DEVELOPMENT REVIEW COMMITTEE (DRC) COMMENT REPORT

PROJECT NAME: 1507 SE 15th Street

CASE NUMBER: R18068

REQUEST: Site Plan Level III Review – 10 Multifamily Residential Units, Yard Modification, Waterway Use

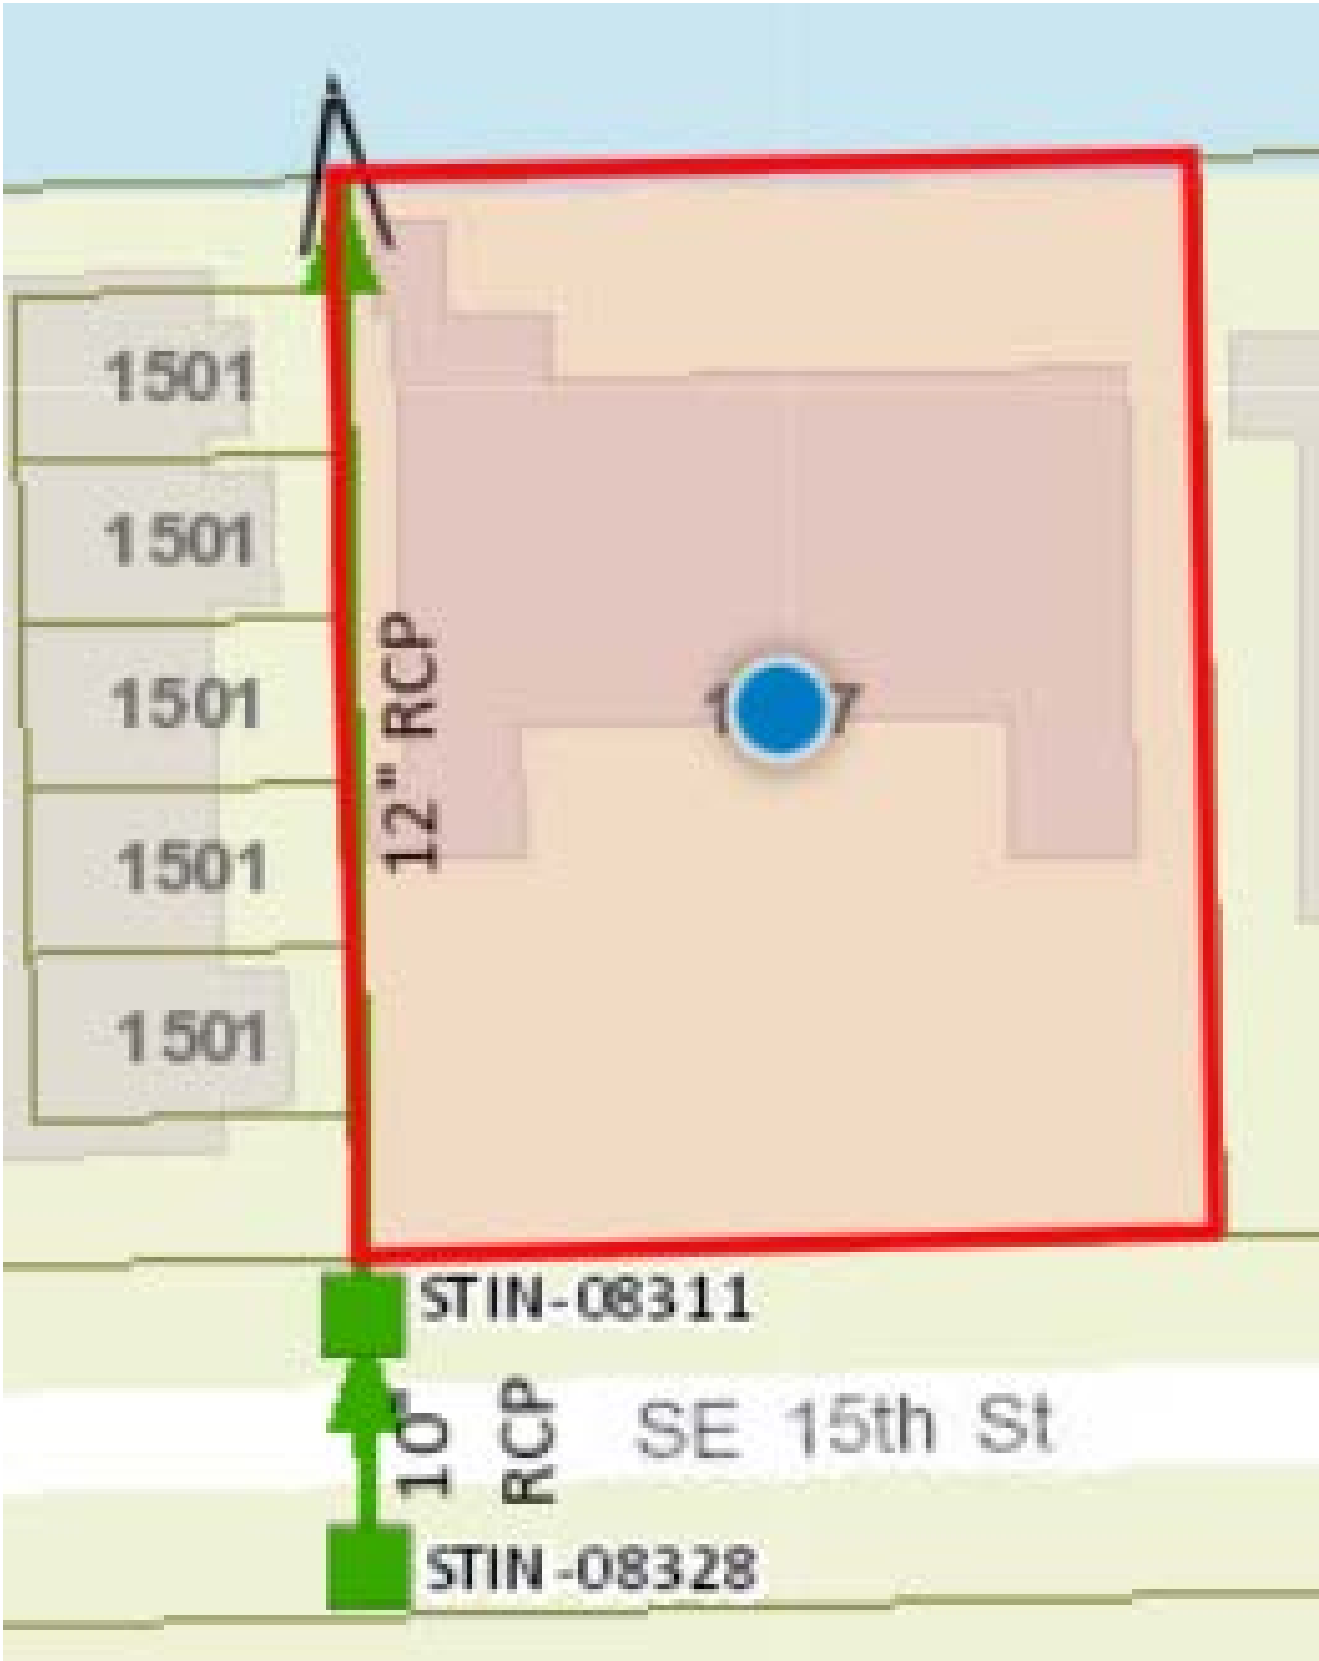
The City owns and maintains stormwater infrastructure adjacent to the proposed development as shown with green line work in the map provided at the end of this report. **Civil plans shall be revised to show the City's stormwater inlet ID #s as identified in the map provided at the end of this report.** The following comments pertain to possible impacts of the proposed development and/or construction activities to the existing condition of the City's stormwater assets. The applicant shall provide an itemized response letter addressing the following comments:

1. Please provide (or revise if already submitted) an erosion, sedimentation, and stormwater pollution prevention plan (**SWPPP**) showing the adjacent City's existing stormwater system as shown in the survey and to the limits shown with green line work in the storm map provided at the end of this report. A copy of the approved SWPP shall be at the construction site from the date of demolition initiation to the date of final construction activities.

- a) Contractor shall provide CCTV videotapes to City STW OPS of the existing stormwater system to the limits shown with green line work in the storm map provided at the end of this report in order to document the PRE and POST construction conditions of the City's storm system.
